Addendum No. 2
August 24, 2022

Project: **St. Mary Catholic School Addition & Remodel**
812 N. State Avenue
Dell Rapids, South Dakota 57022
Architecture Incorporated Project #2788

Scope of this Addendum:

SECOND FLOOR PLAN - AREA B - PLUMBING & HEATING
 SCALE 0 4 8 12 16

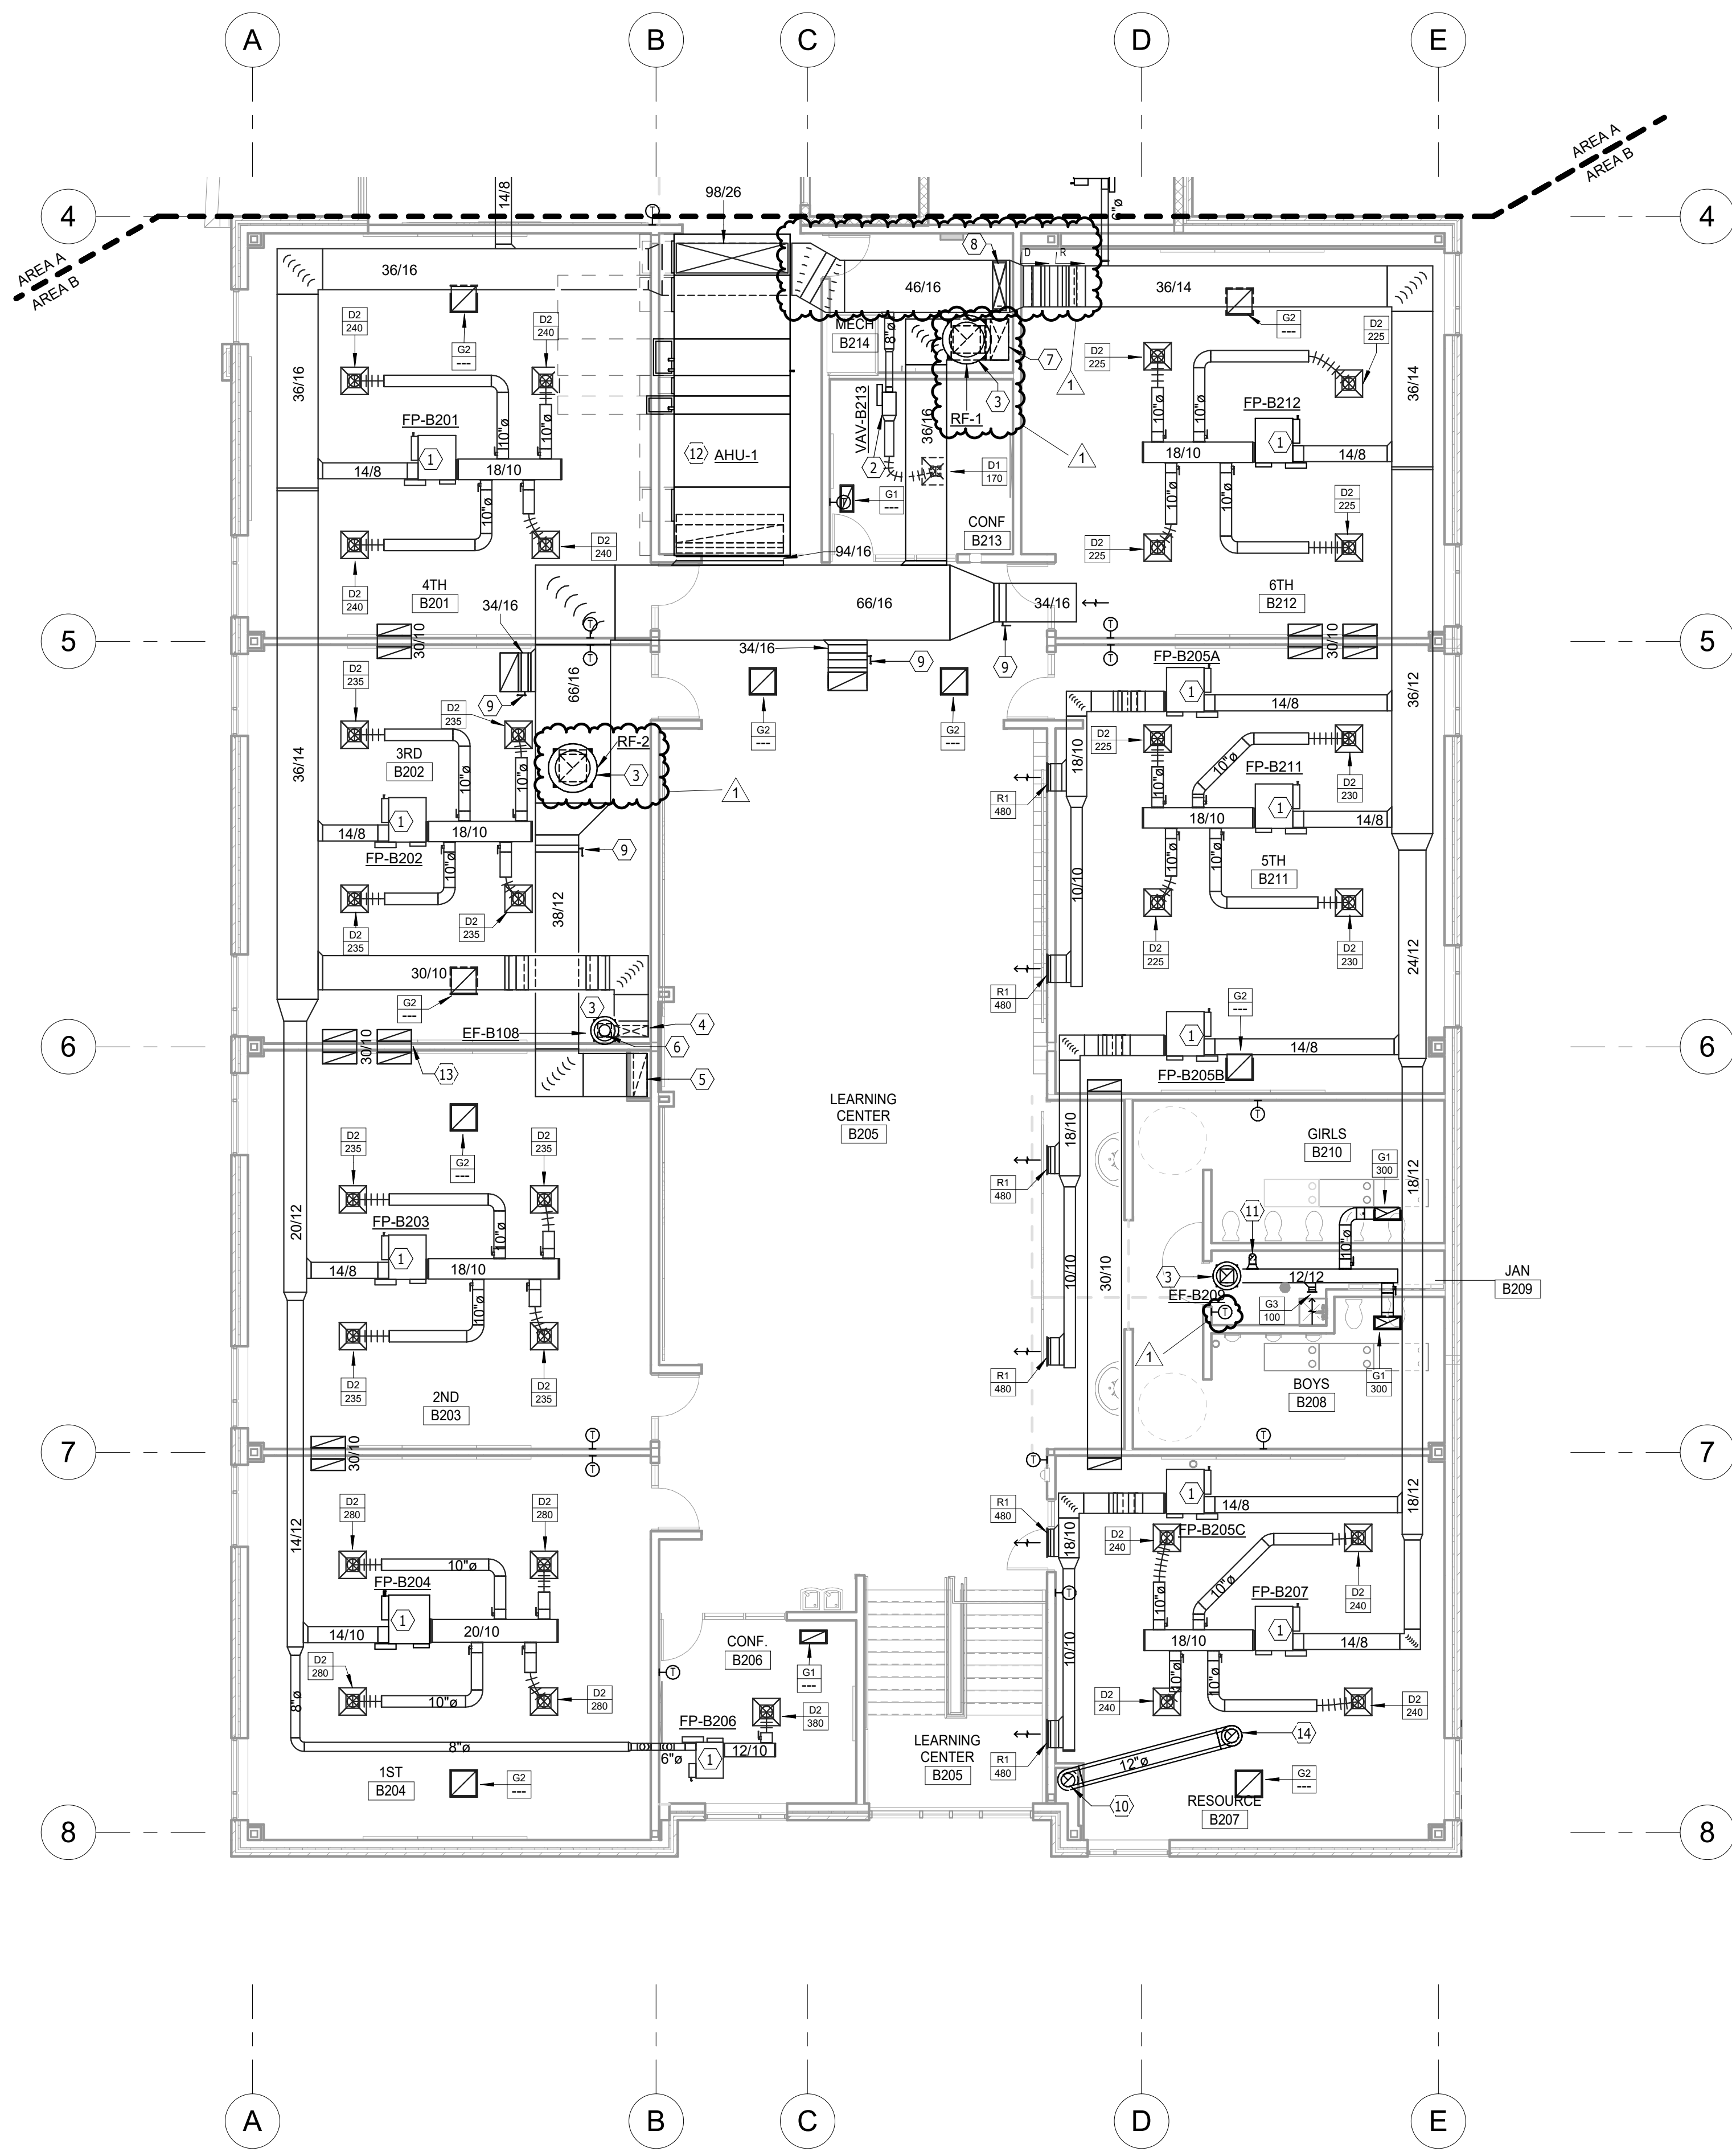
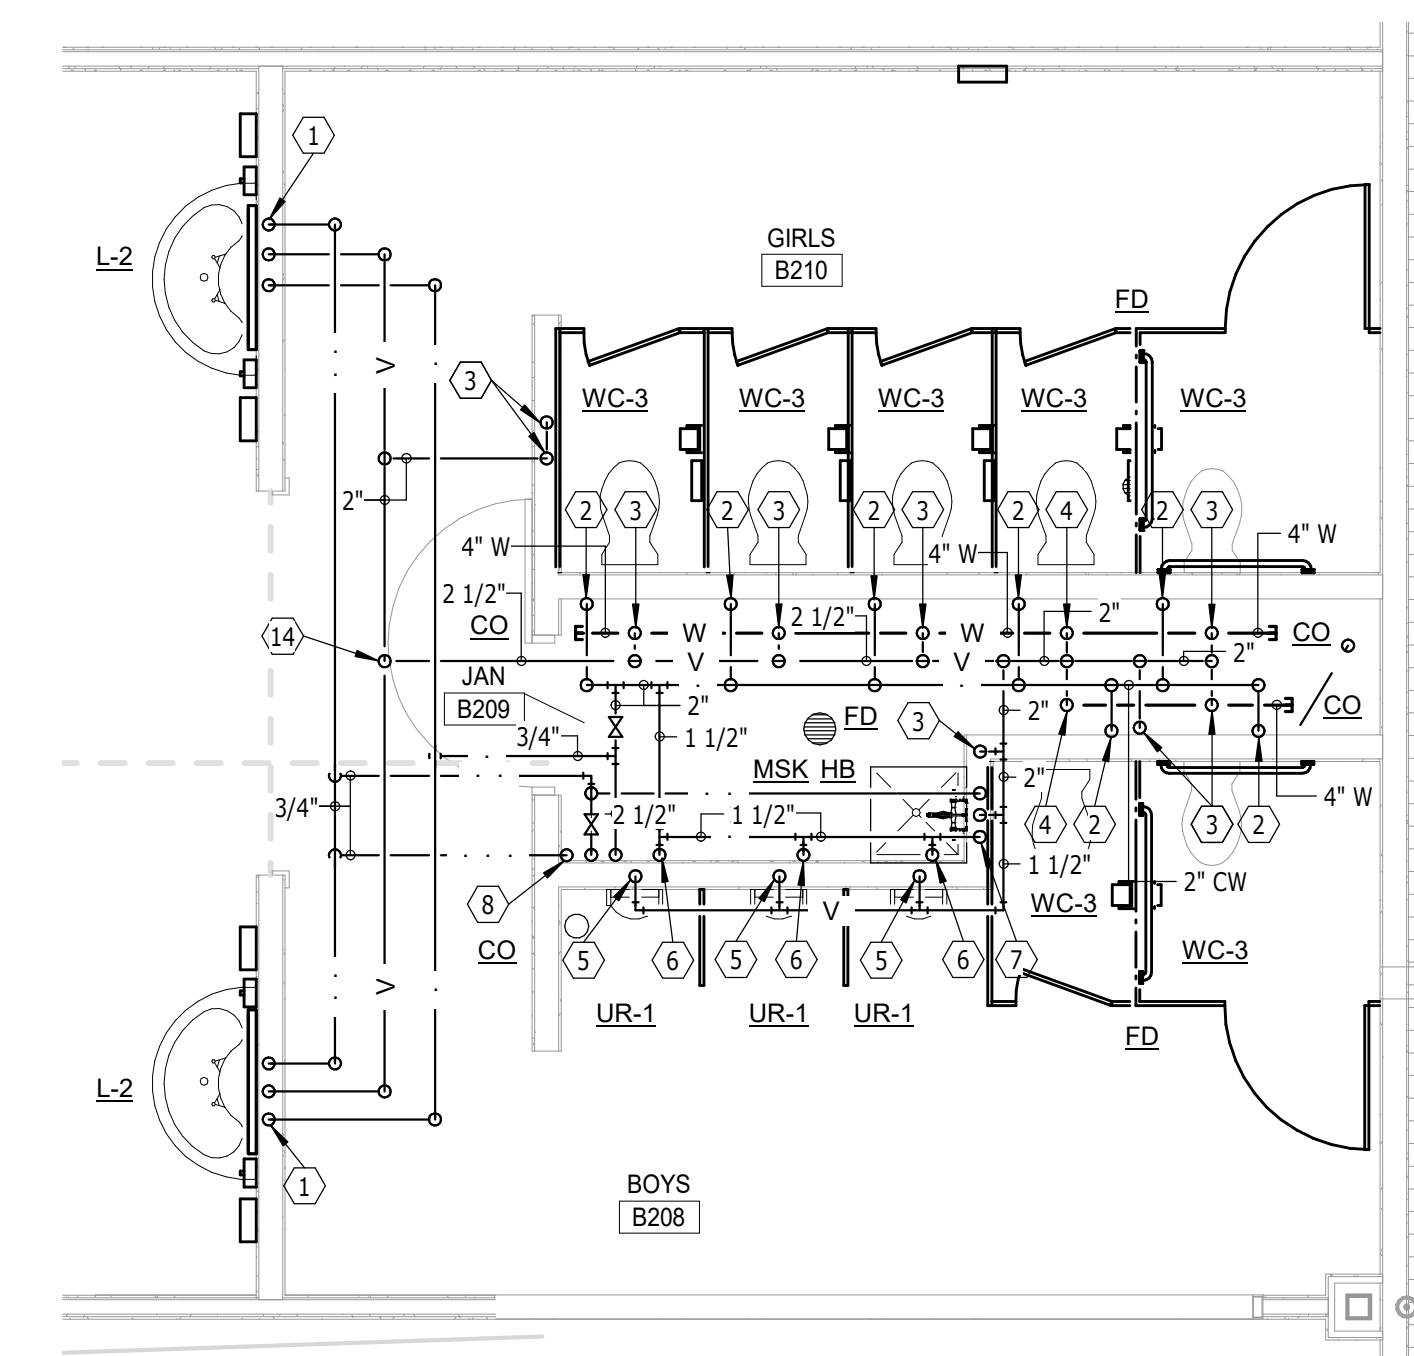
- a. Add electric water cooler & associated piping. See attached sheet.
32. DRAWING SHEET 8.50 – GROUND FLOOR PLAN – AREA A – VENTILATION & A/C
- a. Restroom A33: provide thermostat to control radiant heat.

SECOND FLOOR PLAN - AREA B - VENTILATION & A/C
 SCALE 0 4 8 12 16

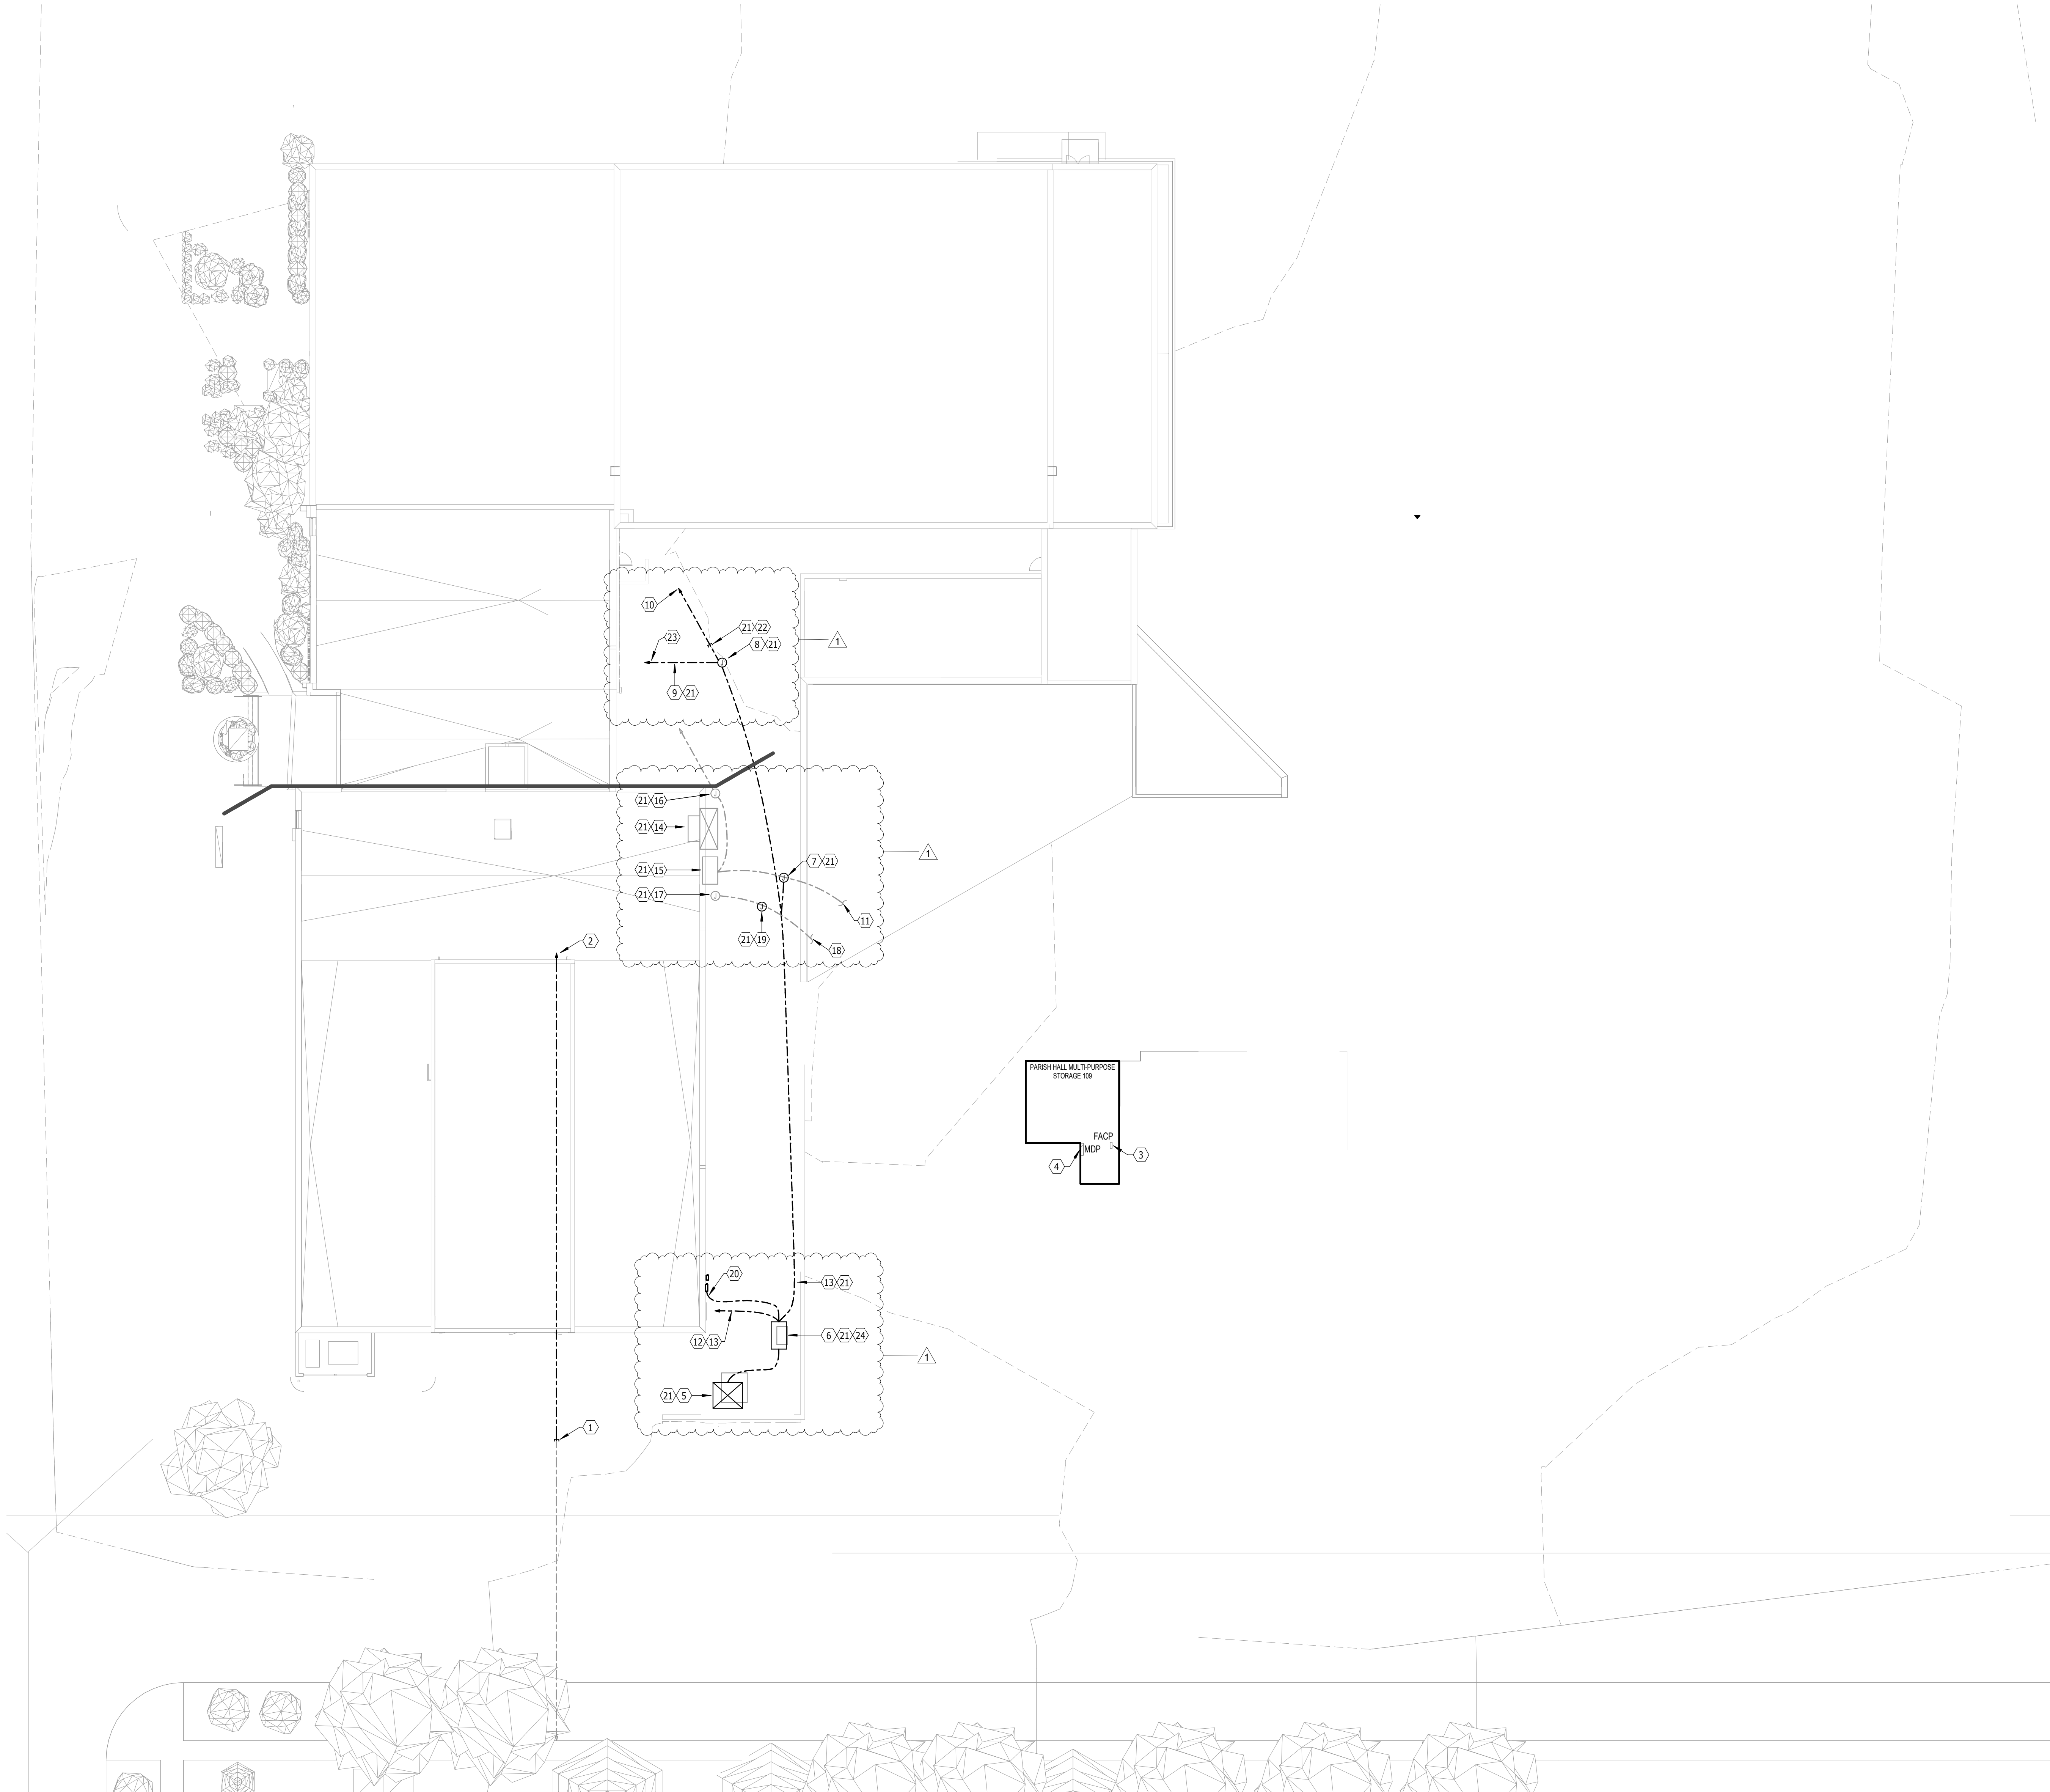
- a. Add roof mounted relief fans RF-1 & 2. Provide with 18” insulated roof curb and motorized damper. Duct down to return air duct and provide insulation wrap.

- b. Add thermostat in Jan B209 to control fin tube heat. See attached drawing sheet.
